## Appendix 8

Reference: 190509.01FC

### LETTER OF ADVICE OF PROPOSED RESOURCE RECOVERY FACILITY AT 7 MONTORE ROAD, MINTO

Reference is made to your request to provide Letter of Advice for the Proposed Resource Recovery Facility at 7 Montore Road, Minto (Concept Site layout in **Annexure A**). This letter addresses comments from the Department of Planning in reference to *M<sup>C</sup>Laren Traffic Engineering's (MTE) Traffic and Parking Impact Assessment (TPIA)* dated 5<sup>th</sup> February 2019 (ref 18259.01FB). The Department comments are quoted below followed by **MTE's** responses.

## ANNEXURE C: SWEEP PATH TESTS (SHEET 1 OF 2)

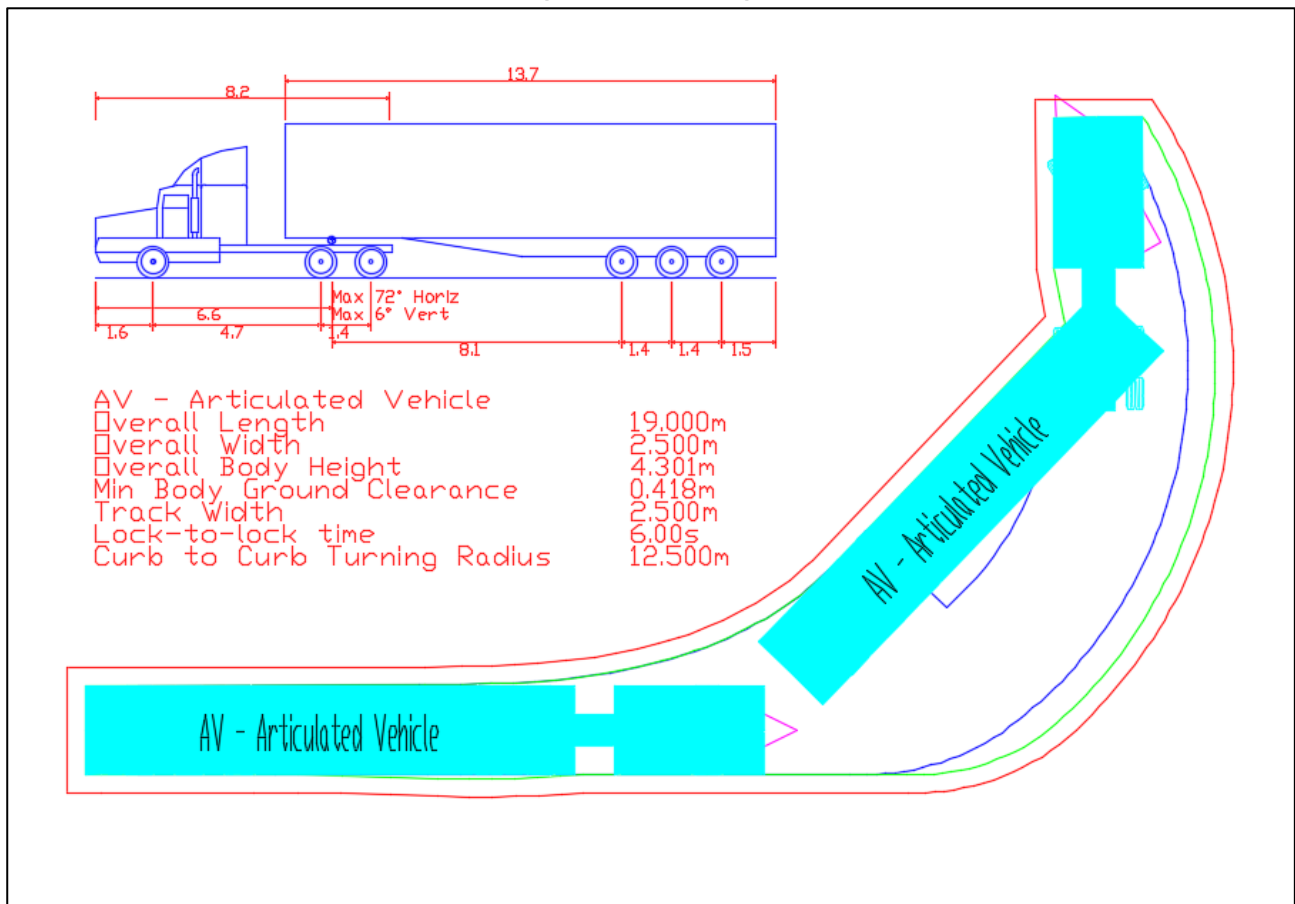
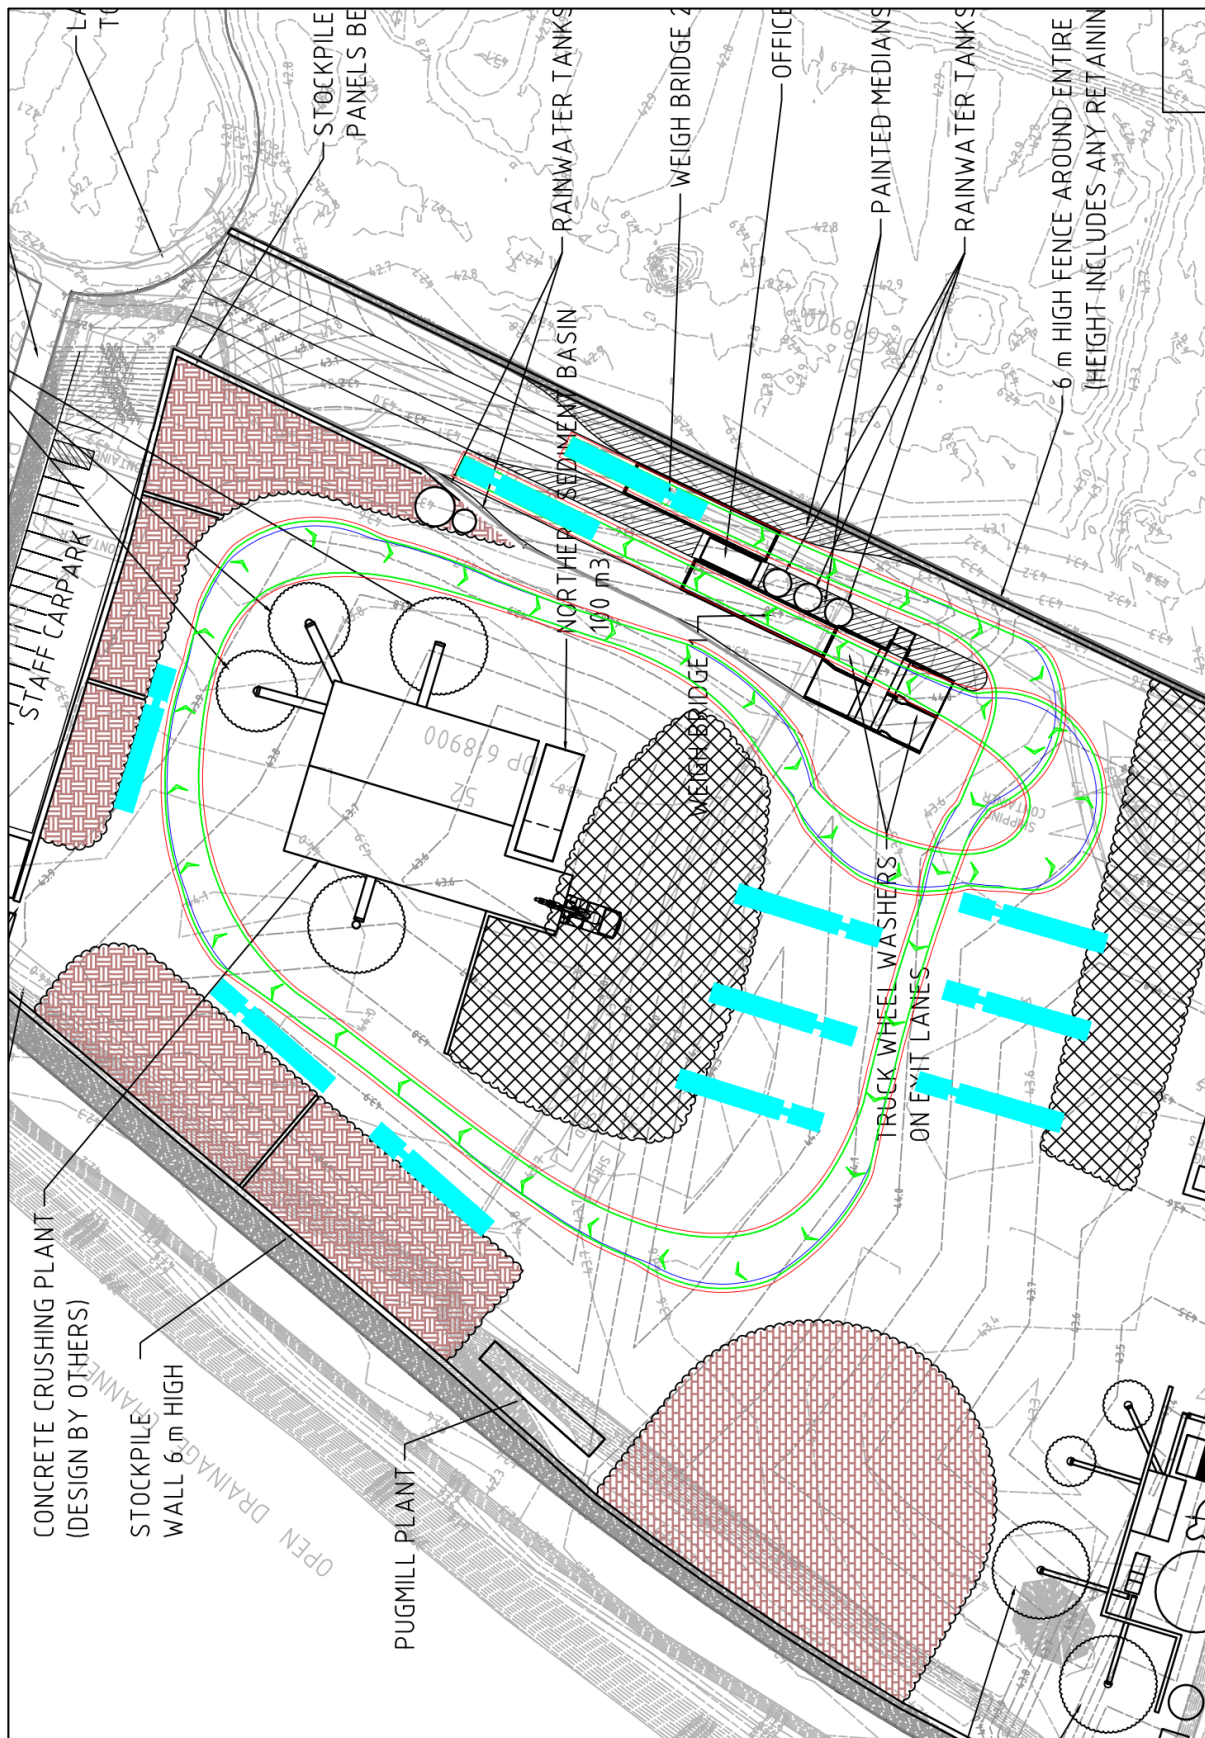
*Section 10.4.3 of the EIS states that each industrial building/unit having a gross floor area more than 1,500m<sup>2</sup> will provide a loading area to allow for heavy rigid vehicles to manoeuvre – please discuss this aspect in the project description and show the loading areas on a plan.*

**MTE Response:** Heavy vehicles up to 19m long articulated vehicles can circulate throughout the site. Loading and unloading operations will occur in multiple locations which can all be accessed by a 19m long articulated vehicle. It is important to note that neither the loading and unloading areas block heavy vehicle circulation around the site, allowing unrestricted vehicle flows within the site. Swept paths of an articulated vehicle circulating the site while loading and unloading activities (shown in indicative locations) are occurring is provided in **Annexure C**. Additionally, the figures provided in **Annexure C** are included in the modified *TPIA*.
